Access Compliance Report

Public Rights-of-Way

(Pedestrian Signals)

Intersection ID: N/A	Main Street:	Cross Street: N/A	Location: N/A
ADA ID: 41F2FD2D9616	Signal Type: One Push Button-Non APS	Overall Compliance: No	Severity Score: BTN 1: N/A BTN 2: N/A No BTN: N/A
Codes/Mitigation Info/Possible Solution		Field Measurements/Component Compliance

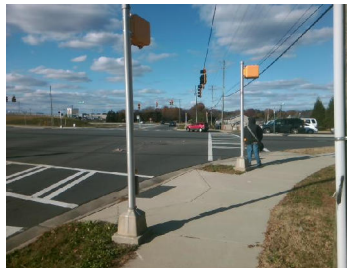
PROW/ADA: R404.2, R406.2

Possible Solutions: Provide Push Button Extension. Remove and Replace Clear Space.
